SWEDISH MEDICAL CENTER CHERRY HILL CAMPUS MAJOR INSTITUTIONS MASTER PLAN CITIZEN'S ADVISORY COMMITTEE

DRAFT Meeting Notes

Meeting #16b

June 26, 2014

Attachment #2 – Height Drawing as provided by Dylan Glosecki

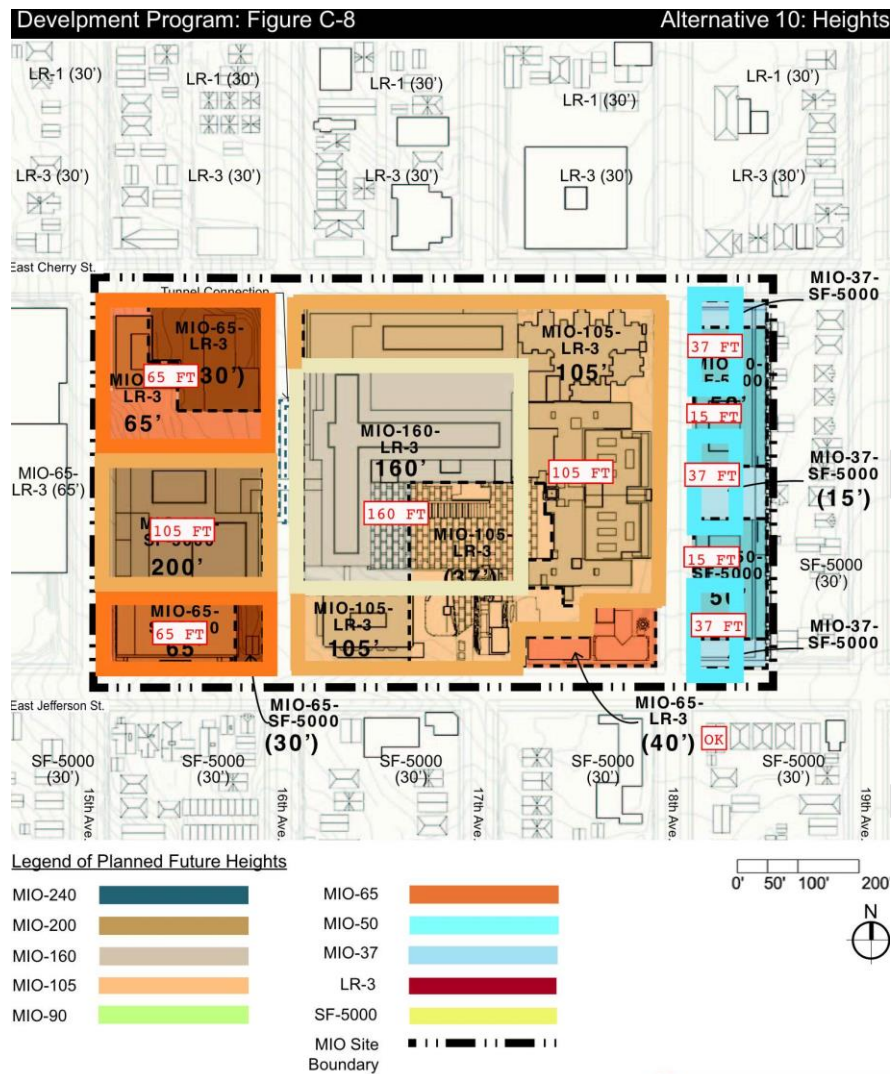
Dylan Glosecki was recognized to discuss his height proposals. He noted that he had developed them after having various conversations with neighbors and a couple of CAC members. Neighbors were clear that 105 feet was a better match to the neighborhood scale. 160 feet was considered appropriate only for the core hospital function on the central block. 200 feet was supported by no one. He therefore decided that a maximum height of 105 ft. height was most reasonable and reflected tht in his suggestions. Other's noted that there was a need for considerably more modulation of the facades on the west block.

Mr. Sheppard commented that he had stated that a range of 105-160 ft. based upon the heights in Mr. Glocecki's and others maps provided (attachments 1 and 2 to these meeting notes). He noted that there appeared to be a lot of support for 105 ft. but that others suggested 160.
